Report: Test and Balance  
Date: 9/23/2020

**CHICK-FIL-A #01815 PHENIX CITY FSU (PHENIX CITY,  
AL)**

# National TAB

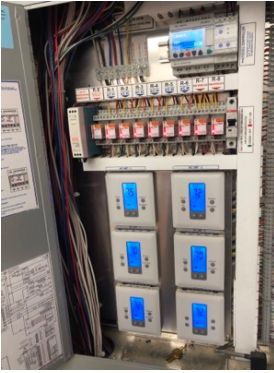
REVIEW + RECTIFY	Humidistat wiring is not landed at the RTU as shown in the mechanical drawings. GND wire and shielded wires are landed at C, but should be landed at drain terminal. See M-4.1 detail 3 for correct wiring diagram.
INFO ONLY	No backdraft damper is installed in the duct for EF3, the restroom exhaust fan. This fan is also not secured to the curb. The fan is existing and installation of the backdraft damper is not in the scope of work. Listing as an issue since it is a deviation from typical CFA spec.
INFO ONLY	Some existing diffusers do not have hard elbow. Typical CFA design is for all diffusers to have a rigid 90 degree fitting installed per SAG/RAG/Grille Take-off Drawing Sheet M-3.1. Existing ductwork in dining room area is outside of the scope of construction. Listed as it is a deviation from typical CFA spec.
REVIEW + RECTIFY	Diffusers in Mechanical area and kitchen are not placed exactly where shown on plans. Recommend installing per plan on M101.MOD

INFO ONLY	Existing ductwork has dampers on bottom of duct with no ribbon. Typical CFA design is for all damper handles to be installed on left or right side of duct and marked with fluorescent ribbon, per Start Collar Drawing Sheet M-3.1. Insulation completely covers dampers on existing ductwork. Existing ductwork in dining room area is outside of the scope of construction. Listed as it is a deviation from typical CFA spec.
INFO ONLY	There is no hard pipe after start collar on some existing ductwork. Typical CFA design is for all diffuser take-offs to have at the minimum 1' of hard duct installed per Start Collar Drawing Sheet M-3.1. Existing ductwork in dining room area is outside of the scope of construction. Listed as it is a deviation from typical CFA spec.
INFO ONLY	Existing ductwork uses more than 4' of flex in places. Typical CFA design is for a maximum of 48" of flex duct for each diffuser run per SAG/RAG/Grill Take-off Drawing Sheet M-3.1. Existing ductwork in dining room area is outside of the scope of construction. Listed as it is a deviation from typical CFA spec.

CRITICAL	AC1 return drop has a hard 90 installed that is not shown in drawings. Supply airflow is 89% AC1 and this deviation appears to be a source of restriction. See M-3.1 detail 6 for how duct should be installed. Appears the duct was installed this way due to lack of space above the ceiling. IF the duct cannot be installed per design, recommend consulting the engineer of record to determine next steps.
REVIEW + RECTIFY	More than 4' of flex on AHU1 diffusers. Plans specify a maximum of 48" of flex duct for each diffuser run per SAG/RAG/Grill Take-off Drawing. See sheet M3.1 detail 6.
REVIEW + RECTIFY	AHU1 has dampers on bottom on horizontal duct. Plans call for all damper handles to be installed on left or right side of duct and marked with fluorescent ribbon, per Start Collar Drawing. Vertically installed dampers can restrict airflow. See sheet M3.1 detail 6.
REVIEW + RECTIFY	AC2 annunciator is not labeled. Other labels do not meet specification. Install labels per Smoke Detector and Annunciator Wiring Diagram Sheet M-4.1

REVIEW + RECTIFY	No dampers installed in existing ductwork for restroom diffusers. Women's RR airflow is high and cannot be decreased because there is no damper for the individual diffuser. Airflow in women's restroom is 285 CFM out of 180 CFM design. This is higher than the exhaust rate, and is therefore positively pressurizing the restroom. Recommend installing dampers for diffusers in both the women's and men's restrooms.

6 SUPPLY & RETURN DROP GEOMETRY  
SCALE: N.T.S.

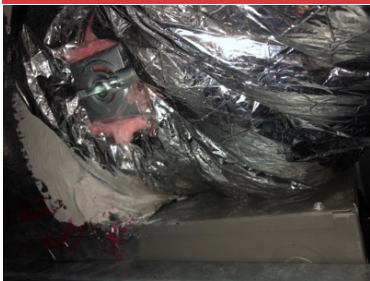
**AC1 RETURN DROP IS A HARD 90 WITHOUT GRADUAL ANGLE**

Airflow is low on AC1 and return drop is a hard 90. See M-3.1 detail 6. There does not appear to be room in the ceiling for proper transition.

See detail 6 on sheet M3.1. This is the largest deviation to specification that was noted.

### **MORE THAN 4' OF FLEX ON AHU1 DIFFUSERS**
